# Access Compliance Report

## Public Rights-of-Way

Intersection ID: 15160	Main Street: GRIFFITH_ST	Cross Street: S_TRYON_ST	Location: SW
ADA ID: 576B087FAC83	Ramp Type: Perp	Initial Pass/Fail: Fail	Overall Compliance: No
		Severity Score: 10

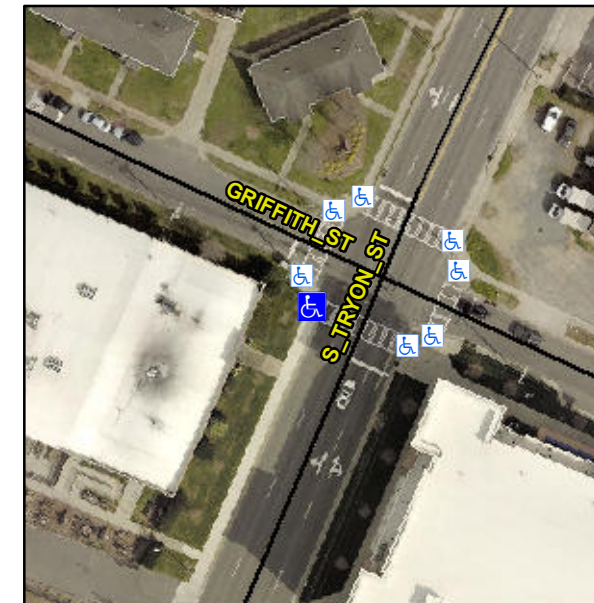
**Not Found, R304.5.1, R304.5.3**

Compliance	Description	Data	Compliance	Description	Data
N/A	Ramp Length (in)	62.0	Yes	Ramp Slope (%)	7.3
No	Ramp Width (in)	47.0	No	Ramp XSlope (%)	3.8
N/A	Flare Type LT	N/A	N/A	Flare Type RT	N/A
N/A	Flare Slope LT (%)	N/A	N/A	Flare Slope RT (%)	N/A
N/A	Flare Traversable LT?	N/A	N/A	Flare Traversable RT?	N/A
N/A	Landing Length (in)	N/A	N/A	DWS Provided?	N/A
N/A	Landing Width (in)	N/A	N/A	DWS Contrast?	N/A
N/A	Landing Slope (%)	N/A	N/A	DWS Length (in)	N/A
N/A	Landing X Slope (%)	N/A	N/A	DWS Full Width?	N/A
N/A	Landing Curb? (Y/N)	N/A	N/A	DWS Offset (in)	N/A
N/A	Shared Landing?	N/A			
N/A	Gutter Ponding?	N/A	N/A	Gutter Slope (%)	N/A
N/A	Gutter Lip Ht (in)	N/A	N/A	Gutter X Slope (%)	N/A
N/A	Painted X Walk1?	Yes	N/A	Painted X Walk2?	N/A
	X Walk 1 Direction	To SE		X Walk 2 Direction	N/A
N/A	X Walk 1 Width (in)	115.0	N/A	X Walk 2 Width (in)	N/A
	X Walk 1 Slope (%)	1.8		X Walk 2 Slope (%)	N/A
	X Walk 1 X Slope (%)	1.5		X Walk 2 X Slope (%)	N/A

**Remove & Replace Entire Ramp.**
